**RELICENSING STUDY 3.3.8**

**COMPUTATIONAL FLUID  
DYNAMICS MODELING IN THE  
VICINITY OF THE FISHWAY  
ENTRANCES AND POWERHOUSE  
FOREBAYS**

**ADDENDUM**

**Northfield Mountain Pumped Storage Project (No. 2485)  
and Turners Falls Hydroelectric Project (No. 1889)**

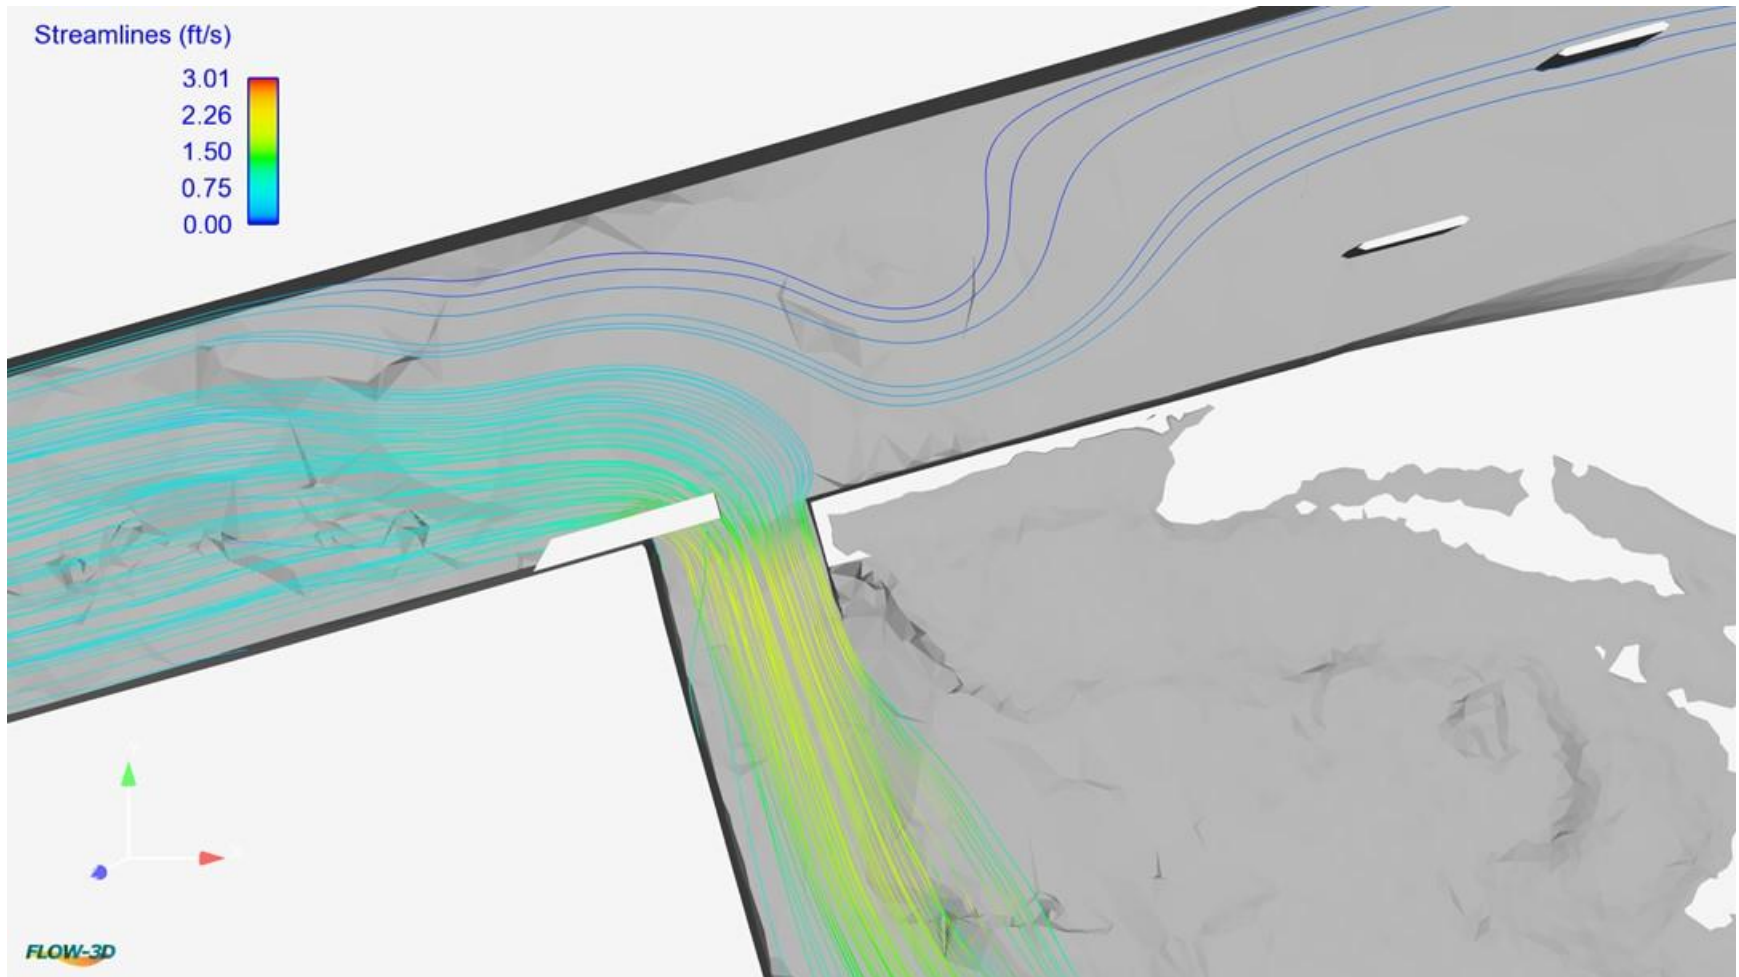
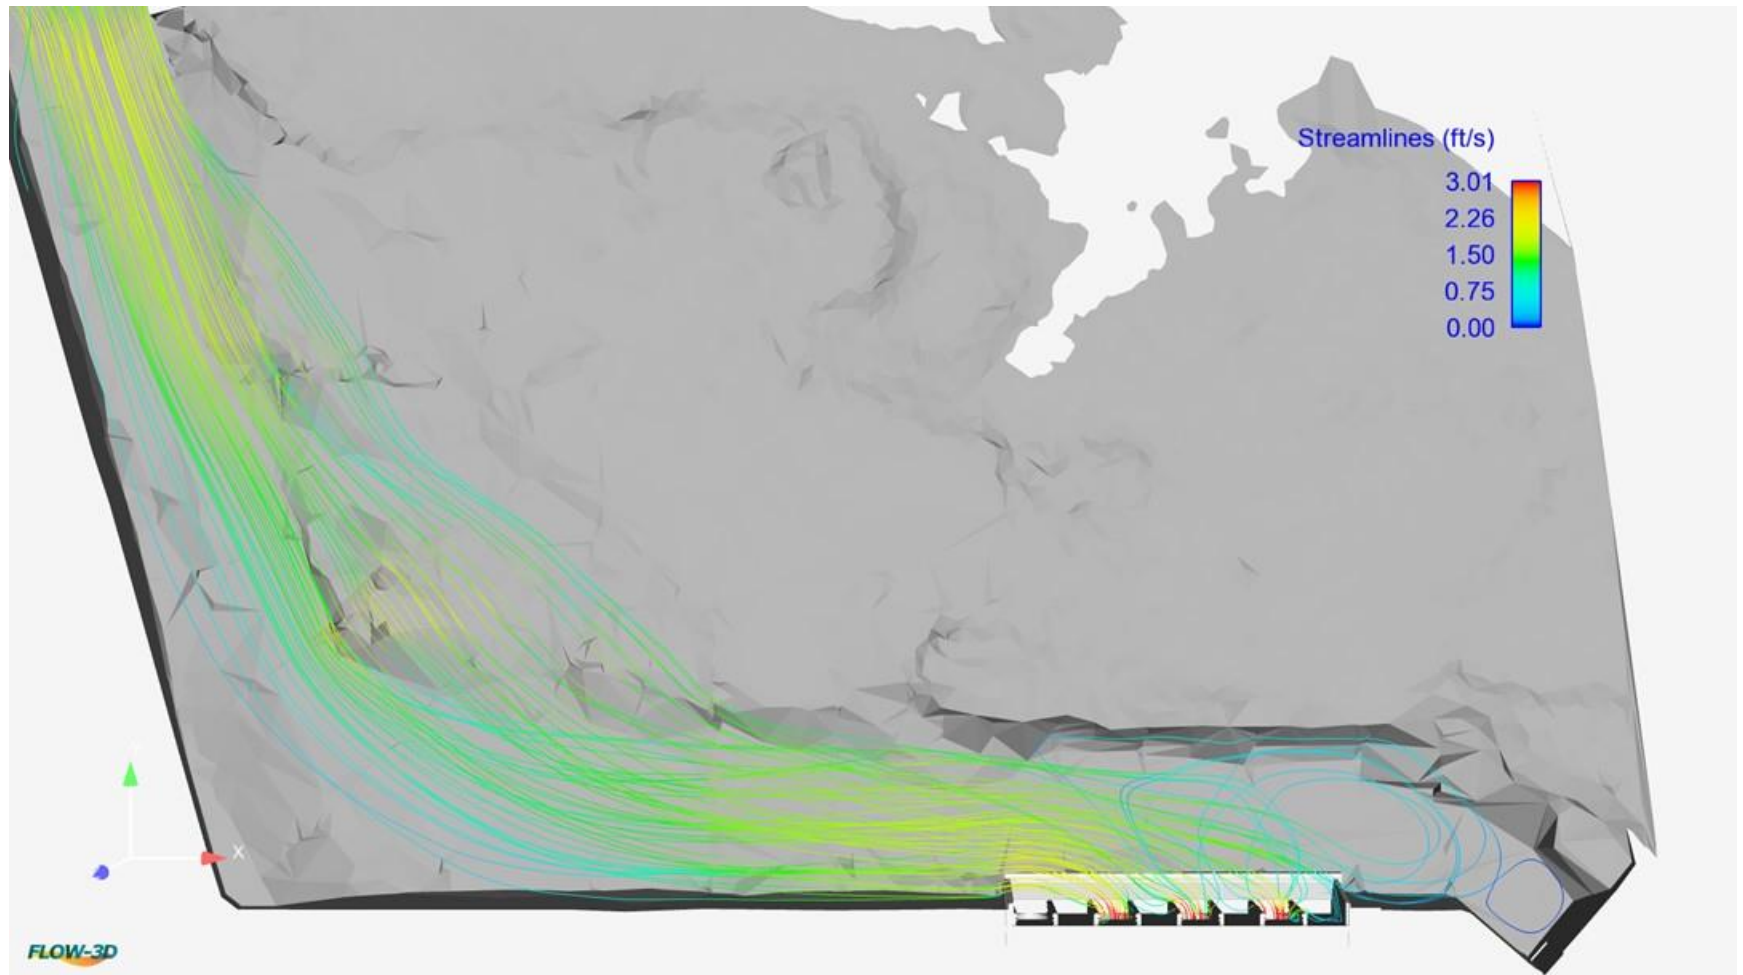
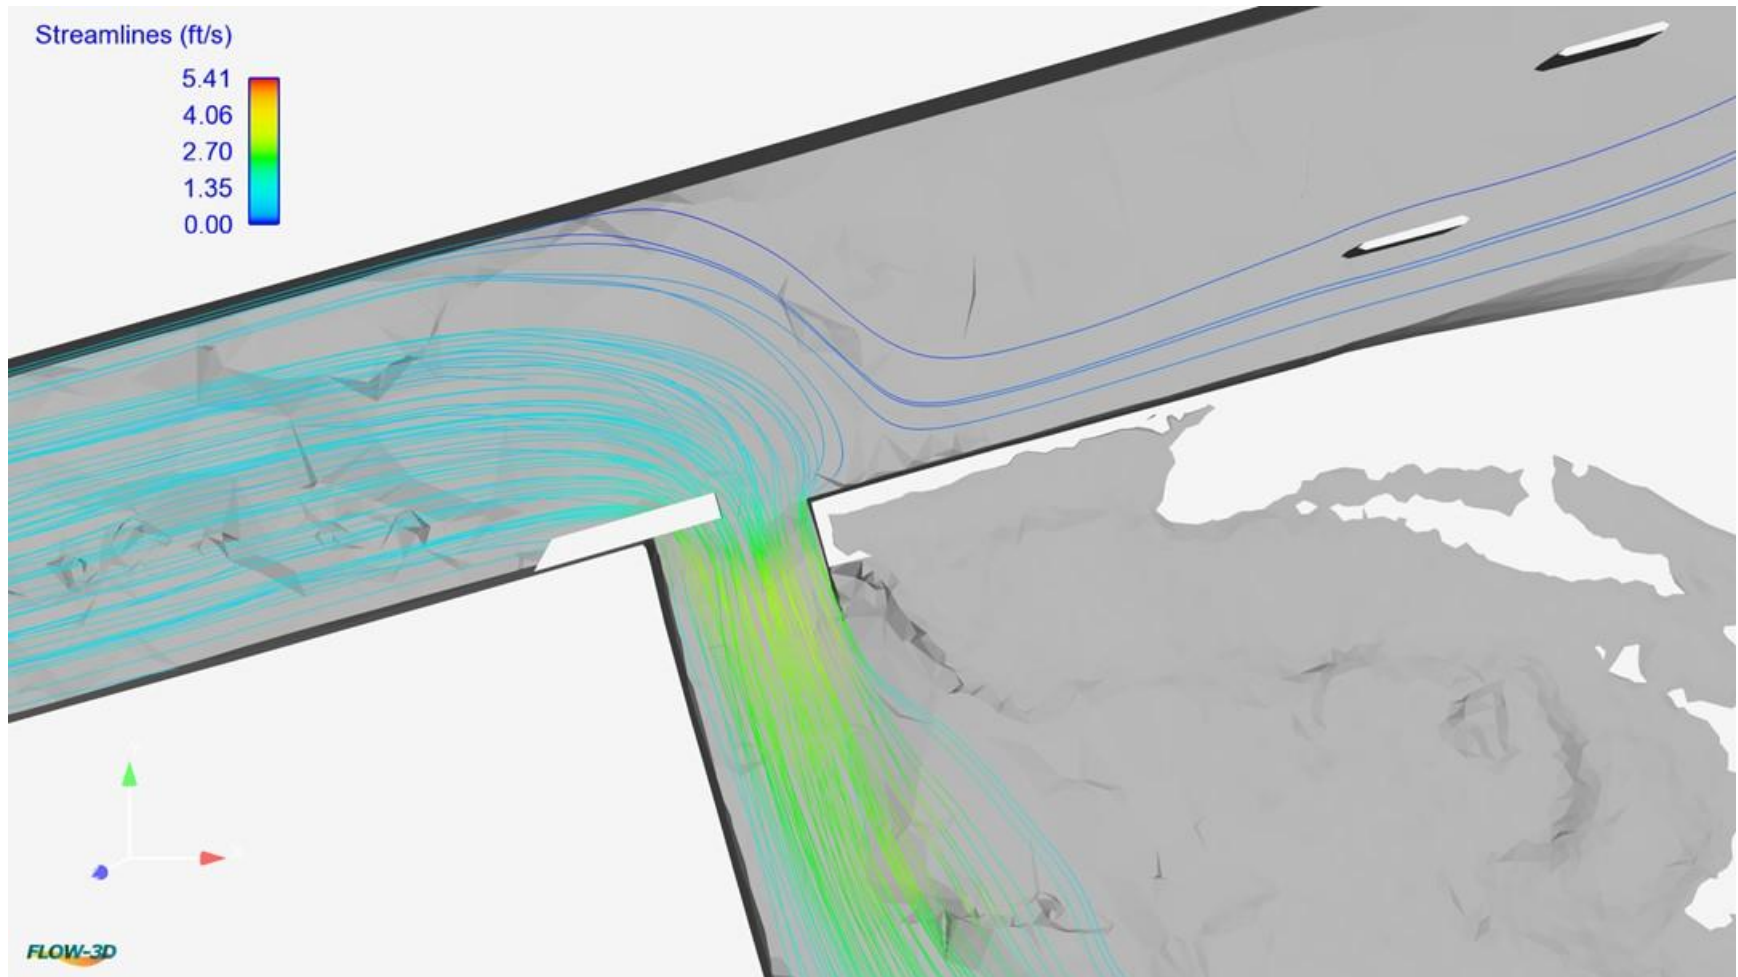
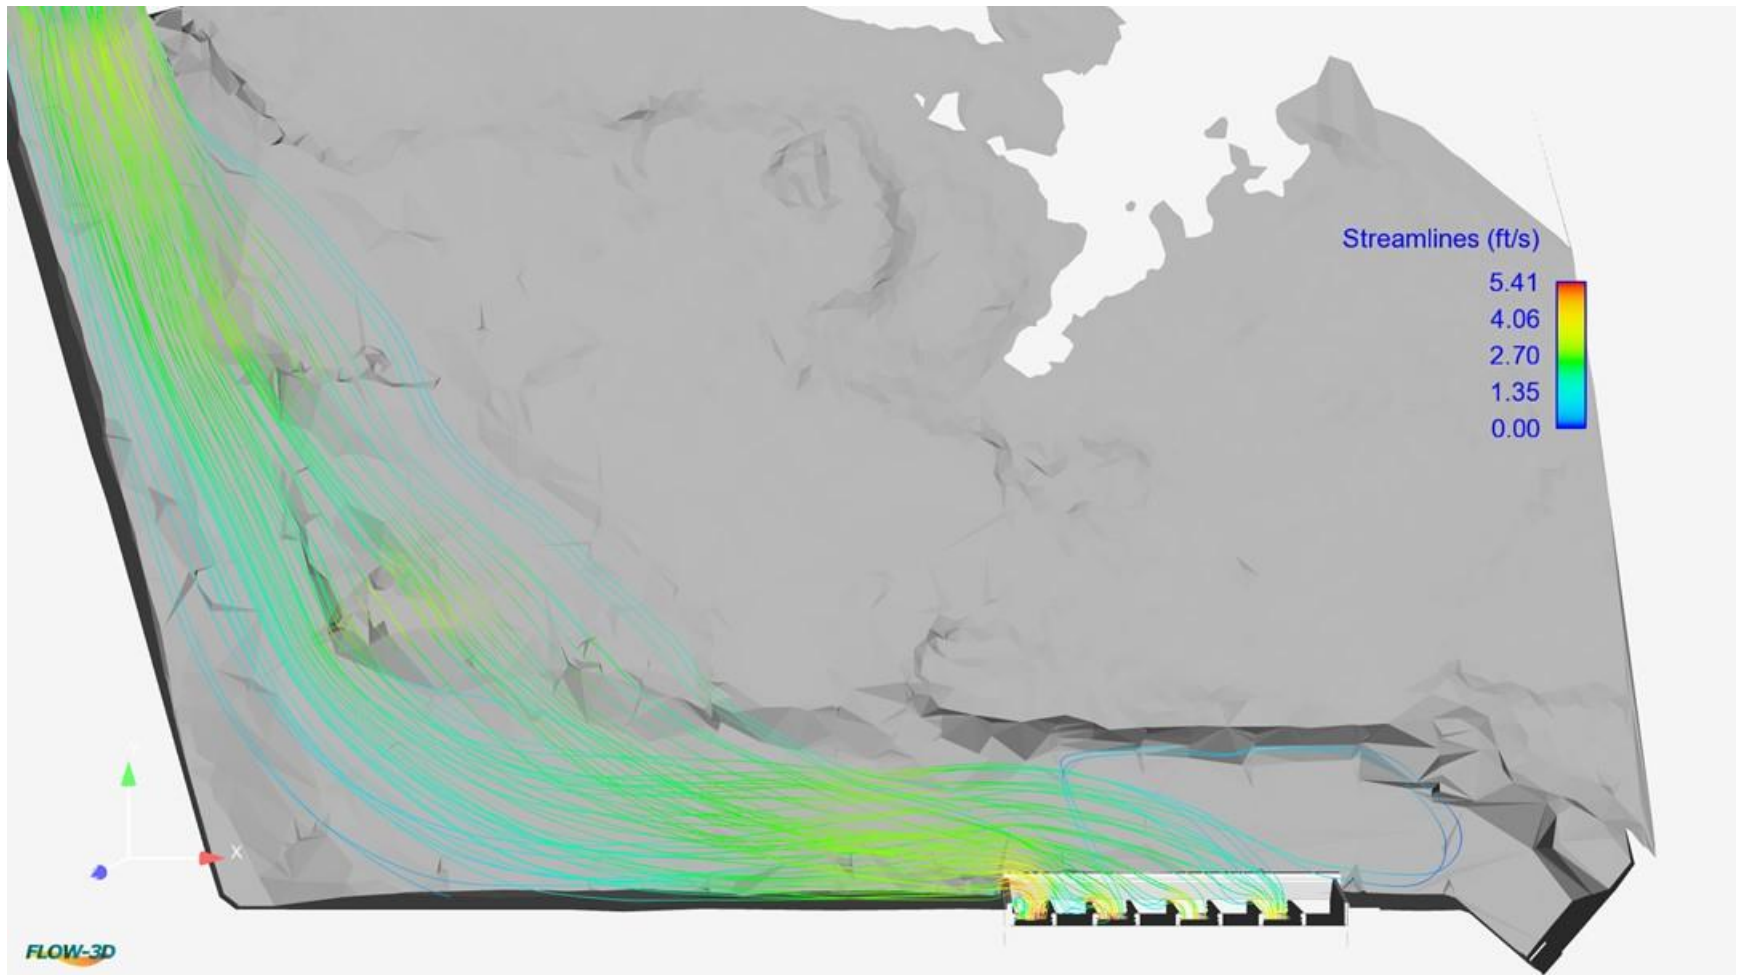
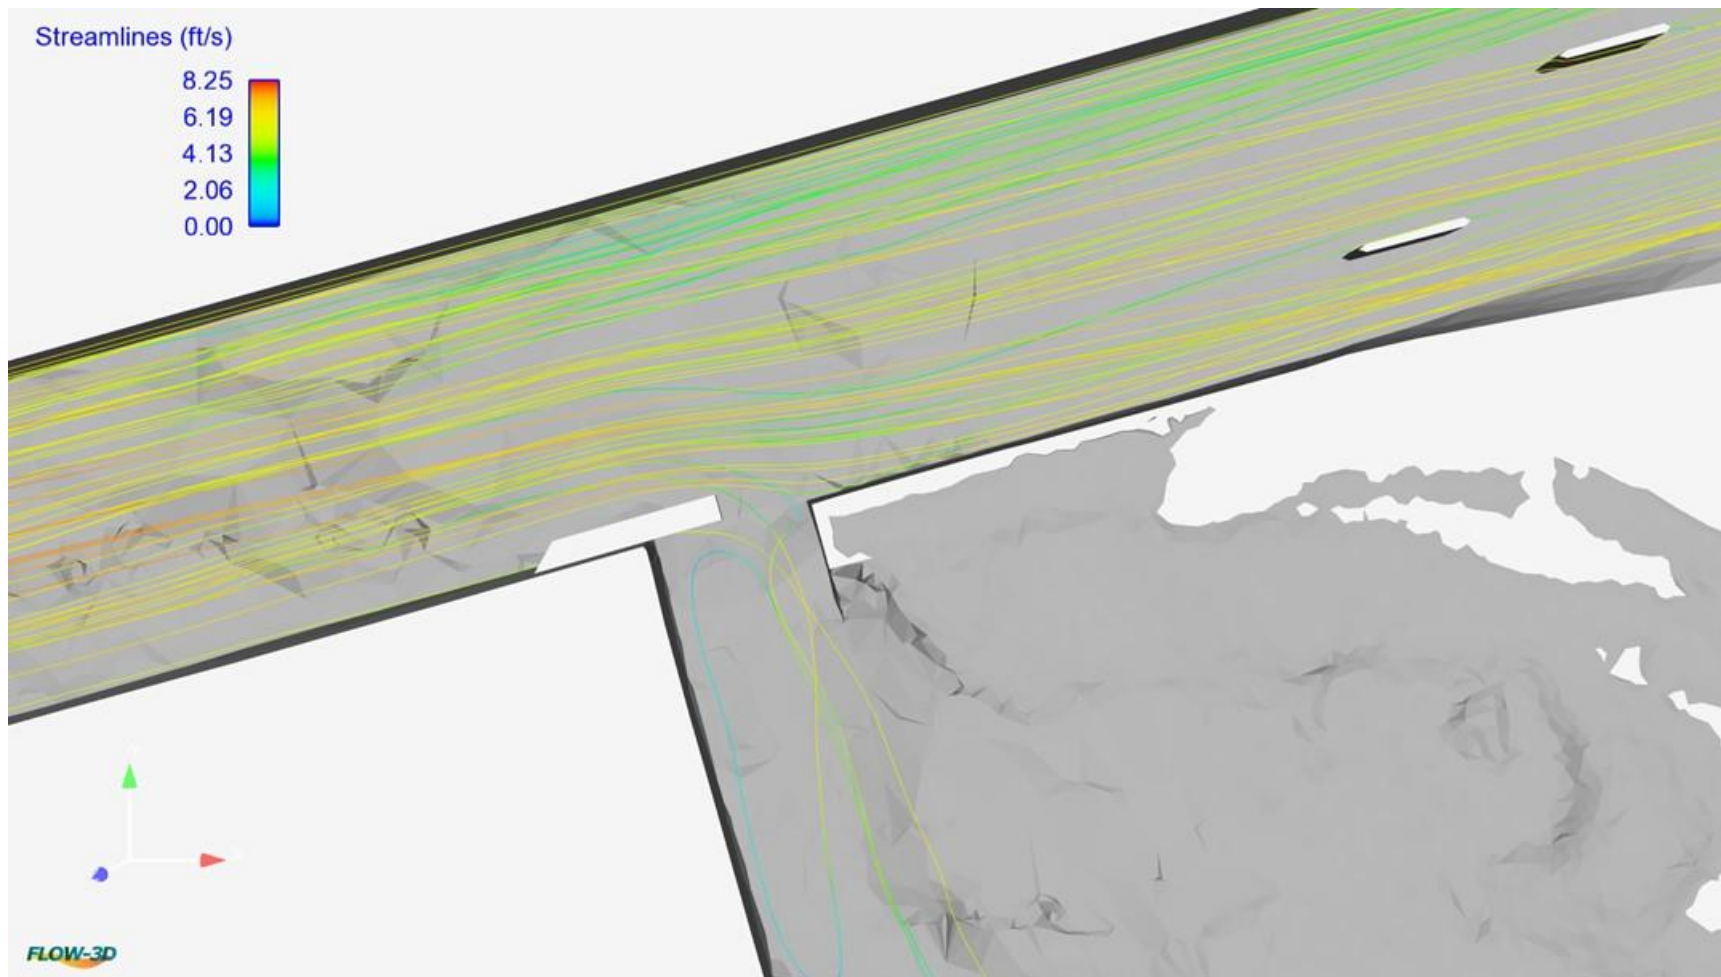
Comment: *To help us better understand the entrainment potential of juvenile alosines, we request that FL produce particle trace plots showing a similar perspective as the flow vector plots in figures 8.2.1-1, 8.2.1-2, 8.2.1-3, 8.2.2-1, 8.2.2-2, 8.2.2-3, 8.2.3-1, 8.2.3-2, and 8.2.3-3. If possible, for clarity, please include at least five seeds in each particle trace plot. It is our understanding that generating these plots will not necessitate new production runs. Relative to the Cabot Intake overview plots.... Similar to the above request, we request that FL produce particle trace plots similar to figures 8.3.1-1, 8.3.1-2, 8.3.2-1, 8.3.2-2, 8.3.3-1 and 8.3.3-2 for the Station No. 1 intake. If possible, for clarity, please include at least five seeds in each particle trace plot. It is our understanding that generating these plots will not necessitate new production runs.*

Particle trace plots for the flows in the Station No. 1 Power Canal and Forebay under Scenario 1-1 are shown in [Figures 2.4-1](#) and [2.4-2](#), respectively. Particle trace plots for the Station No. 1 Power Canal and Forebay under Scenario 1-2 are shown in [Figures 2.4-3](#) and [2.4-4](#), respectively. Particle trace plots for the Station No. 1 Power Canal and Forebay under Scenario 1-3 are shown in [Figures 2.4-5](#) and [2.4-6](#), respectively.
